UNITED STATES PATENT AND TRADEMARK OFFICE

APPLICATION NO.	FILING DATE	FIRST NAMED INVENTOR	ATTORNEY DOCKET NO.	CONFIRMATION NO.
10/561,532	12/19/2005	Ronald Dekker	NL02 1153 US	9985

Office Action Summary	Application No. 10/561,532	Applicant(s) DEKKER ET AL.	
	Examiner Michael B. Shingleton	Art Unit 2815

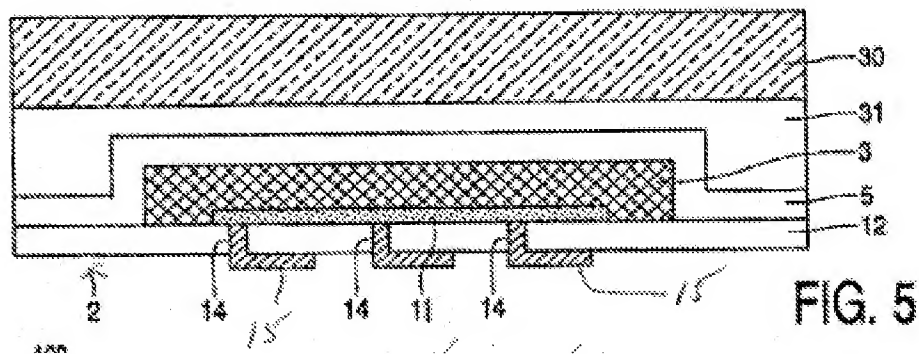
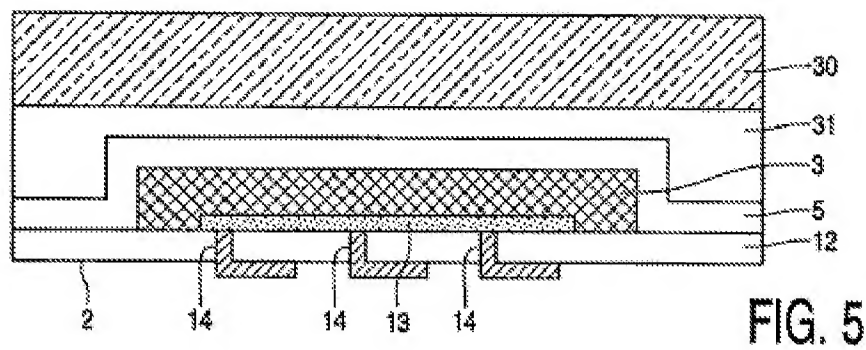
Claims 1, 3-7, 9 and 11 are rejected under 35 U.S.C. 112, first paragraph, as failing to comply with the written description requirement. The claim(s) contains subject matter which was not described in the specification in such a way as to reasonably convey to one skilled in the relevant art that the inventor(s), at the time the application was filed, had possession of the claimed invention. Newly proposed drawings and the specification contain new matter that is required to be cancelled in response to this office action. Specifically, one issue of new matter rests in the functional layer now indicated as 15 in the newly submitted drawings. There is absolutely no support for this in the original disclosure. In fact the original disclosure as well as the newly presented drawings clearly prove beyond any doubt that this "15" cannot be the functional layer. Here's why; in the marked up copy of the specification it states:

The originally Figures and the newly proposed figures clearly show what applicant now refers to as "functional layer 15" as being composed of exactly the same material as that in the apertures 14 which as noted above can only be metal (Note the cross hatching.). That's the original disclosure.

Thus there is absolutely no question that what applicant now points to as element 15 can only be that of metal which makes the newly added subject matter reciting that the functional layer is by example includes electro-optical layers, etc. is clearly new matter never before presented. Note the new matter below of element 15 :

In addition, FIG. 5 schematically illustrates, in generic form, a functional layer 15 present on the second side 2 of the insulating layer 12. The term 'functional layer' is to be understood to mean a layer that extends over a substantial part of the substrate area and which fulfills in the device, alone or in combination with the switching elements in the active layer 11, a specific function. Examples include electro-optical layers, conductive layers in which antennas are defined, high-K dielectric layers, such as ferroelectric layers for capacitors, layers for sensor applications, such as adhesion layers comprising antibodies for the adhesion of peptides, proteins or other biological material.

FIG. 5

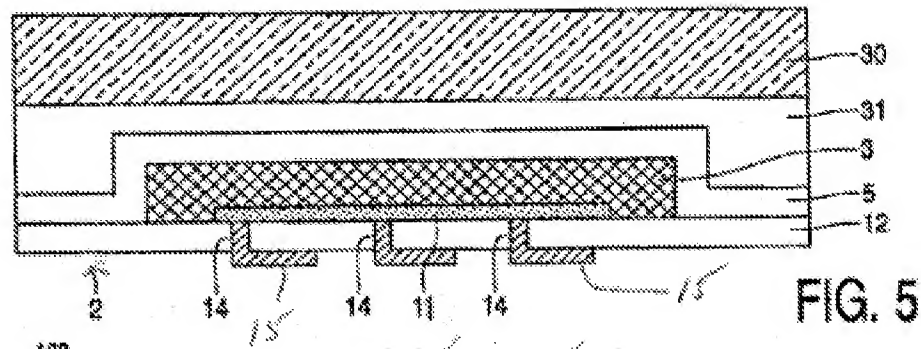
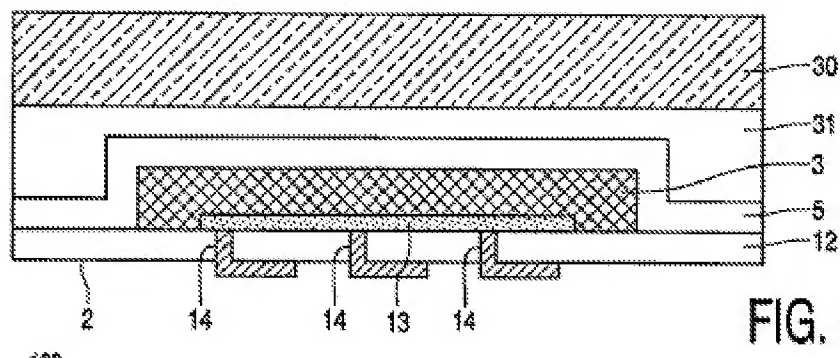
The previous amendment believed to be filed in February of '09 is objected to under 35 U.S.C. 132(a) because it introduces new matter into the disclosure. 35 U.S.C. 132(a) states that no amendment shall introduce new matter into the disclosure of the invention. The added material which is not supported by the original disclosure is as follows: Newly proposed drawings and the specification contain new matter that is required to be cancelled in response to this office action. Specifically, one issue of new matter rests in the functional layer now indicated as 15 in the newly submitted drawings. There is absolutely no support for this in the original disclosure. In fact the original disclosure as well as the newly presented drawings clearly prove that this cannot be the functional layer. Here's why. In the marked up copy of the specification it states:

The originally Figures and the newly proposed figures clearly show what applicant now refers to as "functional layer 15" as being composed of exactly the same material as that in the apertures 14 which as noted above can only be metal (Note the cross hatching.). That's the original disclosure.

Thus there is absolutely no question that what applicant now points to as element 15 can only be that of metal which makes the newly added subject matter reciting that the functional layer is by example includes electro-optical layers, etc. is clearly new matter never before presented. Note the new matter below of element 15 :

In addition, FIG. 5 schematically illustrates, in generic form, a functional layer 15 present on the second side 2 of the insulating layer 12. The term 'functional layer' is to be understood to mean a layer that extends over a substantial part of the substrate area and which fulfills in the device, alone or in combination with the switching elements in the active layer 11, a specific function. Examples include electro-optical layers, conductive layers in which antennas are defined, high-K dielectric layers, such as ferroelectric layers

Applicant is required to cancel the new matter in the reply to this Office Action.
